Super route on east side of South Road

Design of shared pedestrian/cycle paths

30° splay kerb from *The joy of kerbs* by City Infinity, p. 31

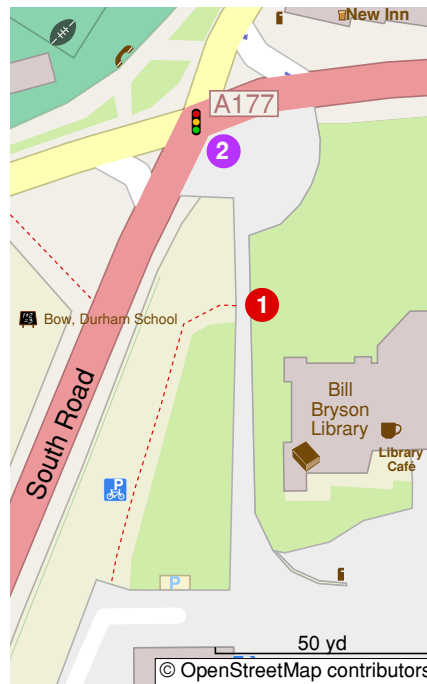
I hope that the University will be able to separate the cycle and pedestrian paths on the main routes. The key to doing this successfully is to make it obvious which path is for which purpose. The painted cycle symbols on the ground and blue circle road signs used by councils are not very effective as they fail to provide an indication along the path. Instead, it is best to design a shallow splayed kerb separating the two modes, with the cycle path at a slightly lower level.

Using a smooth red asphalt for the cycle path and plain asphalt (or paving) for the footway helps, and if the cycle path is bidirectional the Dutch practice is to paint a narrow white dashed line down the middle of it. This makes it obvious to anyone joining the path which part is for cycling on, and which is dedicated to walking.

Other routes on the east side of South Road

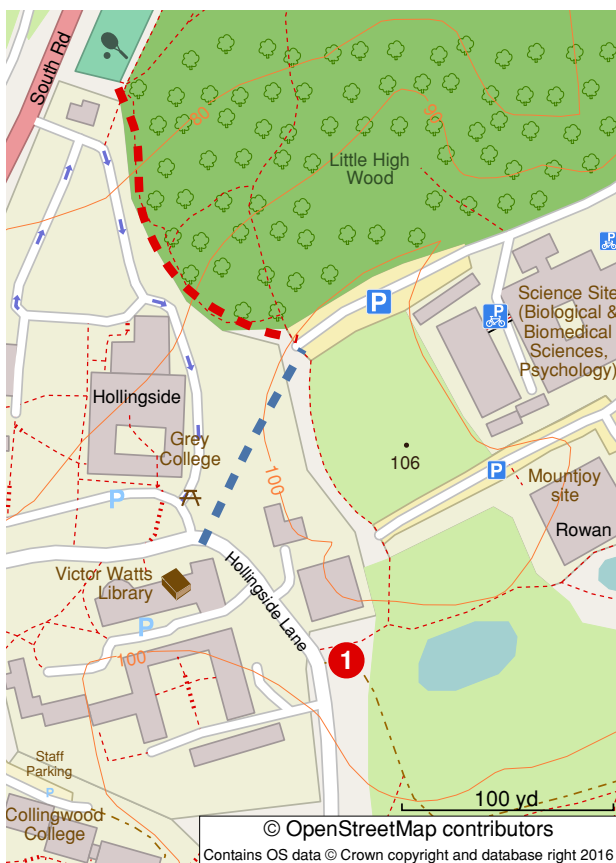
Access to the Upper Mountjoy part of the campus is not as good as it could be, either for walking or cycling. Firstly, it would be helpful for access to Biosciences, Rowan House and the proposed new maths and computer sciences building if there was an alternative to “Cardiac Hill” skirting Little High Wood on the western edge.

Perhaps the informal path that runs along the edge of the wood from the Grey College tennis courts could be improved (marked in red on the map). This would probably only be suitable for those on foot, owing to the gradient. Cycling access could be achieved via the purple route on my first map and then onward via the service road to the east of Grey College, linking with Hollingside Lane.

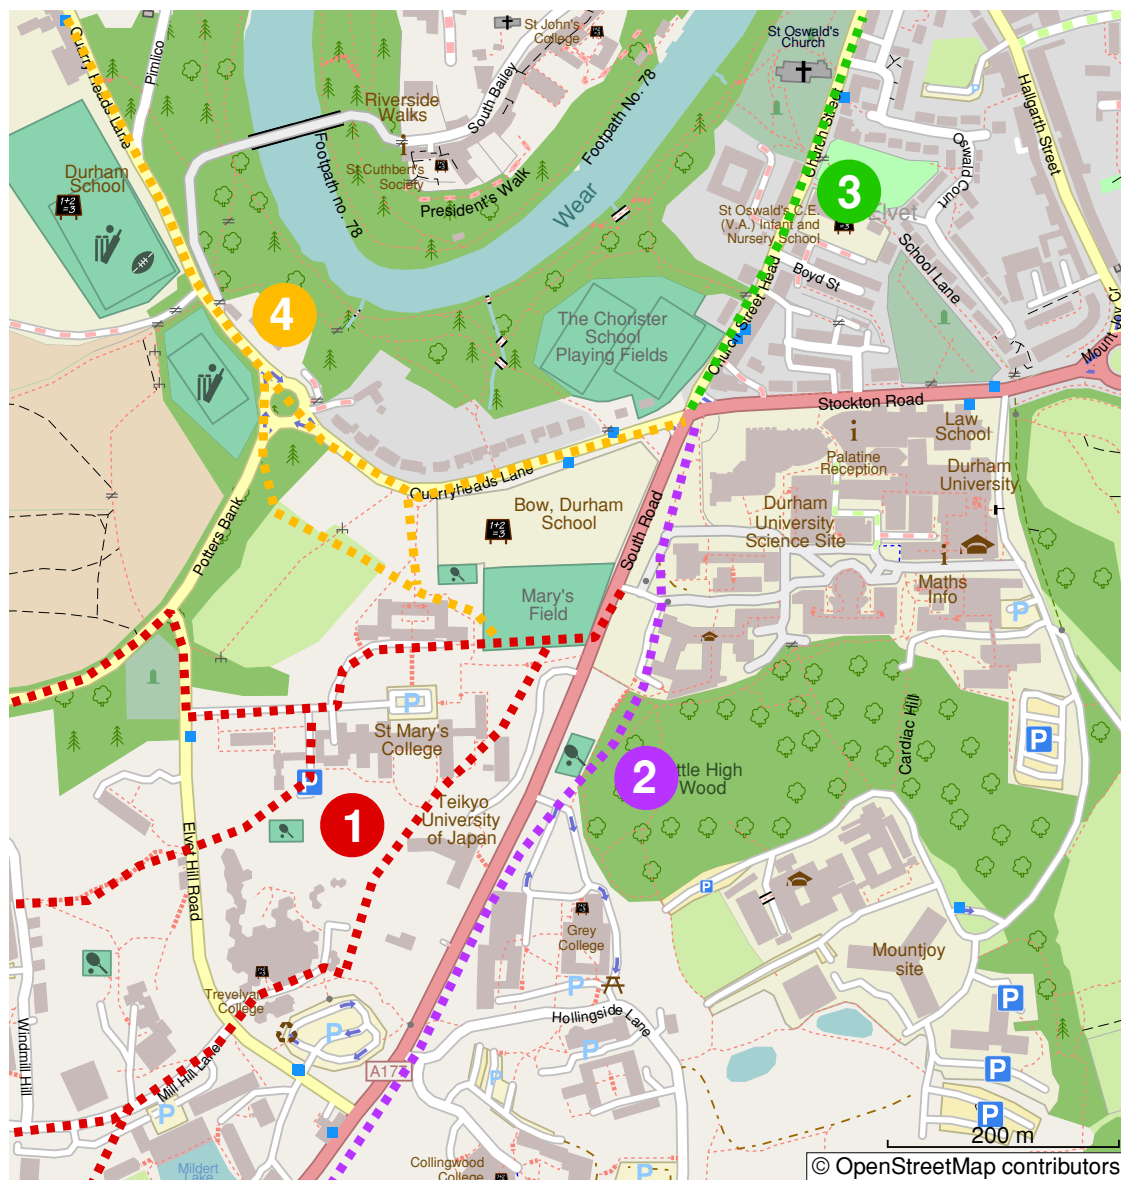
Secondly, the foot and cycle access from Hollingside Lane to the Upper Mountjoy site is quite narrow (marked by 1 on the map). I am not sure how this stands in relation to the proposed car park access road. If the car park access from Hollingside Lane goes ahead then it would be sensible to allow cyclists and walkers to leave Hollingside Lane as early as possible, as the likely volume of car traffic could make it more dangerous.

It would also be possible to make a link as shown by the blue dashed line on the map. Depending on the terrain it may have to include 'switchbacks' to reduce the gradient to acceptable levels.
